## **BAILEE COVE SUBDIVISION**

APPLICATION NUMBER 9 DATE May 6, 2010

REQUEST Subdivision

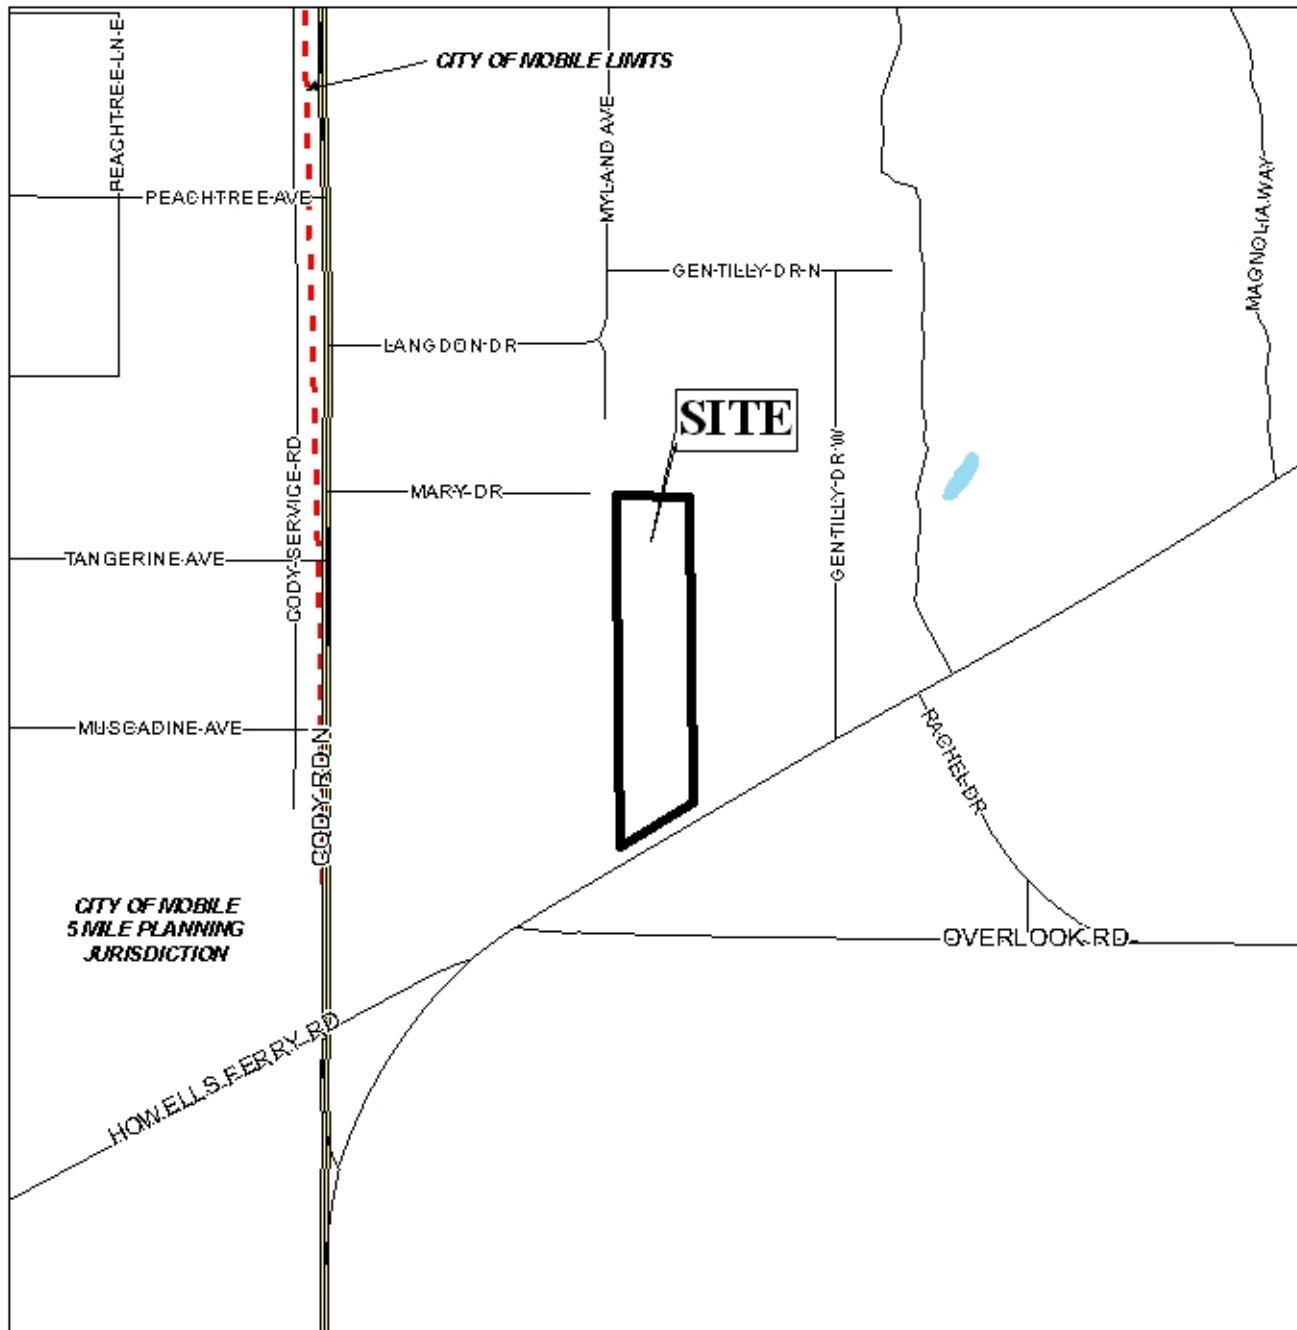
The site fronts Howells Ferry Road, a proposed major street, with 80' of right-of-way. Since Howells Ferry Road is a proposed major street as illustrated on the Major Street Component of the Comprehensive Plan, this section is planned for 100' of right-of-way. The current right-of-way width along the site is 80'; therefore, dedication would be required to provide 50' from the centerline. It should be noted that to the West of the site is a 50' wide unopened right-of-way Myland Avenue, a minor street with out curb and gutter; therefore dedication would be required to provide 30' from the centerline. Myland Avenue is not maintained by the city; therefore, Lot 2 should be denied access to Myland Avenue.

As this site is a corner lot, dedication sufficient to comply with Section V.B.16 of the Subdivision Regulations regarding curb radii should be required. The plat should be revised to depict the dedication of a 25' radius curve at the intersection of Howells Ferry Road and Myland Avenue, after dedication.

As proposed, Lot 2 exceeds the maximum width to depth ratio; therefore, a waiver of Section V.D.3. of the Subdivision Regulations would be required. The Subdivision Regulations states that the maximum depth of a lot should not exceed 3.5 times the width of the lot. While this Section (V.D.3.) is often waived by the Commission, the lots are typically along waterways, or the proposed lots would be characteristic of the surrounding development. In this situation, there are similar subdivisions approximately 600' to the East on Howells Ferry Road, making the proposed plat in character with the area.

It should be noted that there is a dwelling on proposed Lot 2 built in 2008 that is not depicted on the preliminary plat; therefore, staff can not determine if the house meets the required setbacks. However, labeling of the Final Plat with the required setbacks will ensure correct placement of the dwelling.

The lot is labeled on the plat with its size in square feet, and should be revised on the Final Plat to reflect required dedication, if approved.

Finally, the 25' minimum building setback line is depicted on the plat along Howells Ferry Road, and should be revised on the Final Plat to depict the 25' setback for both streets, if approved.

- 1) dedication of sufficient right-of-way to provide 50' from the centerline of Howells Ferry Road, in compliance with the Major Street Plan and dedication to provide 30' from the centerline of Myland Avenue;
- 2) revision of the lot size information to reflect dedication;
- 3) depiction of the 25-foot minimum building setback line along all public rights-of-way including Myland Avenue;
- 4) placement of a note on the Final Plat denying Lot 2 access to Myland Avenue;
- 5) placement of a note on the Final Plat stating that each lot is limited to one curb-cut with the size, location, and design to be approved by Traffic Engineering and conform to AASHTO standards;

- 6) revision of labeling of the size of the lot, in square feet, or provision of a table on the plat with the same information reflecting required dedication;

- 7) dedication sufficient to comply with Section V.B.16 of the Subdivision Regulations regarding curb radii;
- 8) Must comply with Engineering comments: *Must comply with all storm water and flood control ordinances. Must provide detention for any increase in impervious area to the site since 1984 in excess of 4,000 square feet. Show an area reserved for detention on the plat and add a note to the plat that each individual lot will require a land disturbance permit and must provide detention for construction of impervious area in excess of 2,000 square feet. Once developed, if the property does not drain to a City maintained drainage system, then detention for a 100 year storm event with a 2 year release rate will be required unless a release agreement is provided by all downstream properties. Any work performed in the right of way will require a right of way permit;*
